Dwelling type:	House and Garage.
Dwelling configuration:	Double Storey
Nature of works:	New Building.
Stage of inspection:	Fixing & Waterproofing.
Construction Type:	Hebel.
Garage:	Attached.
Foundations:	Slab.
Builder:

An inspection was conducted at the above address on 27/04/2021 for the purpose of a general home inspection, requested by the 'client'.

Schedule of Defects:

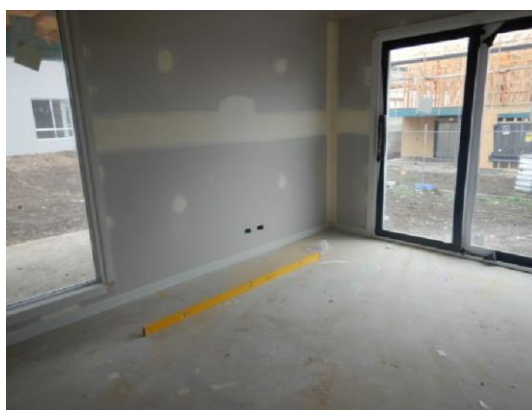
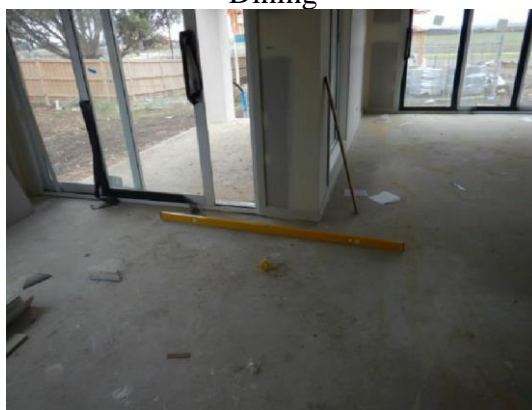
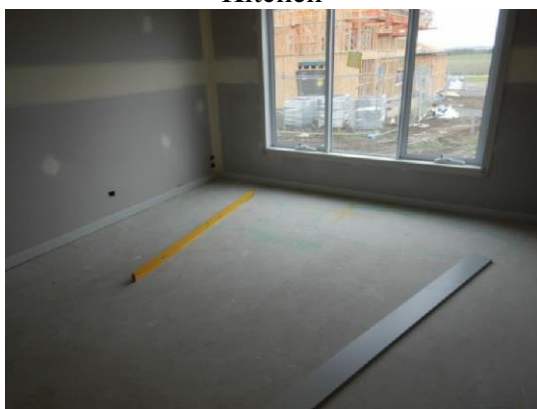
3. Item previously noted, not rectified at the time of Inspection on 27/04/21.
VBA Guide to Standards and Tolerances; 2.08: - New concrete floors must not differ more than 4 mm over any 2 m length or 10 mm in any room or area.

We measured random areas of the concrete slab with a 2 m straight edge and found the slab levels to have not met this requirement.

Note: The builder cannot claim the 10 mm in any room because the 4 mm over 2 m requirement has been breached.

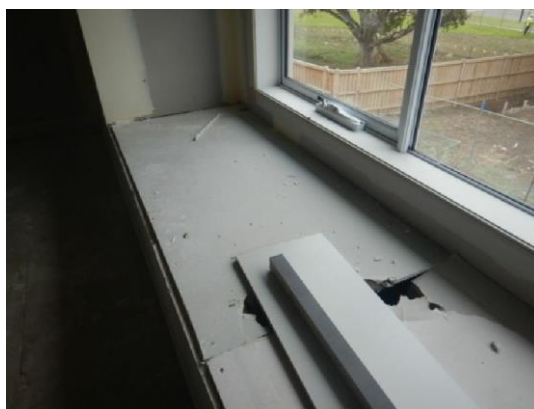
It was noted some elements of work associated with fixing and plastering of the walls, cornices and architraves have not been completed at the time of inspection. All works will require to be set in accordance with the requirements for a level 4 finish prior to application of base coat painting.

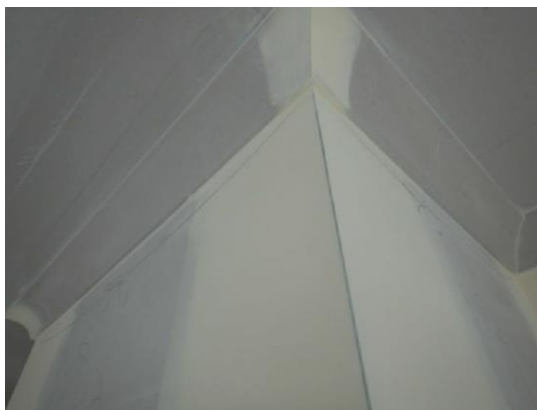
We noted the plaster wall below the cornice in a few areas is showing a noticeable bow. This bow is causing visible thickening of the cornice adhesive at the junction to the cornice bottom edge.

The builder will need to plaster float these areas to present a flat plastered surface that aligns evenly to the cornice underside. Thus, ensuring a proper finish with reasonable care and skill.

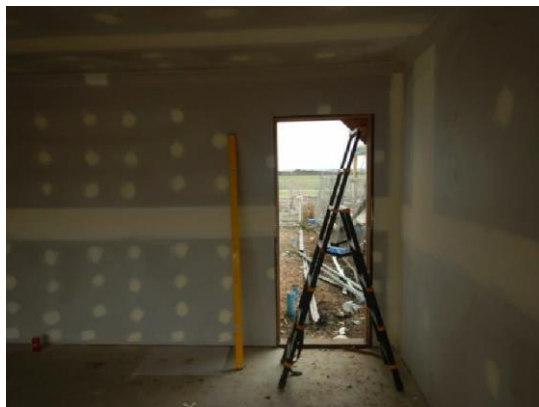
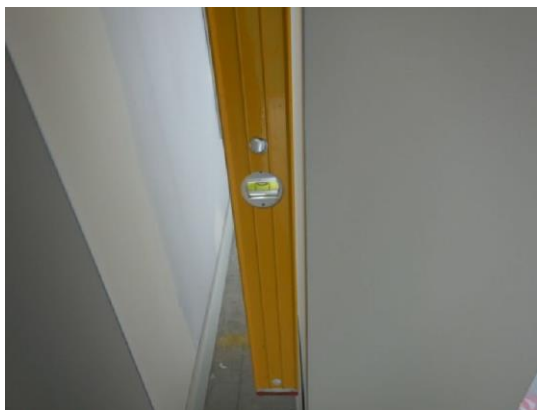
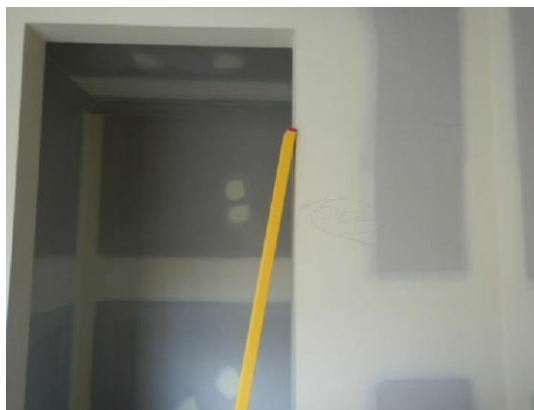
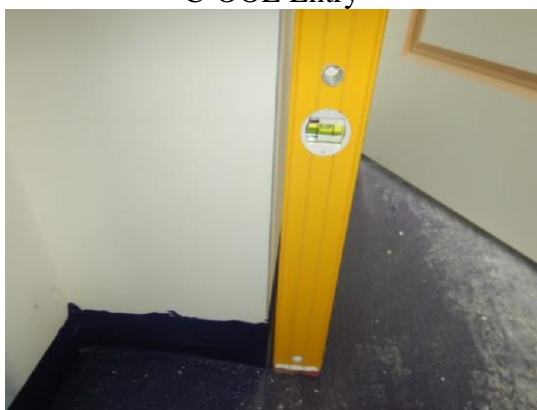
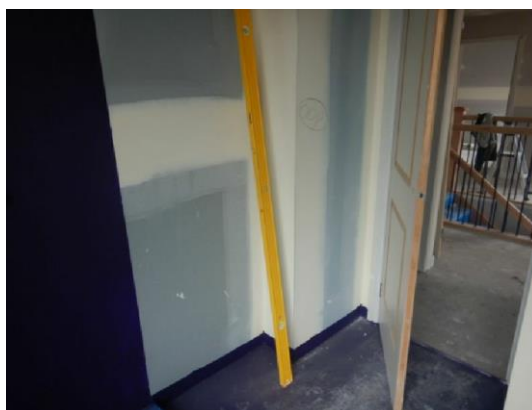
There are a few areas in the home that exceed the allowance of 4 mm tolerance over 2 m.

- out of plumb walls (OOP)
- ceiling or cornice out of level (C-OOL)

As stated, the acceptable allowance is 4 mm over 2 m. These walls will need to be reworked to ensure that the builder complies with this requirement.
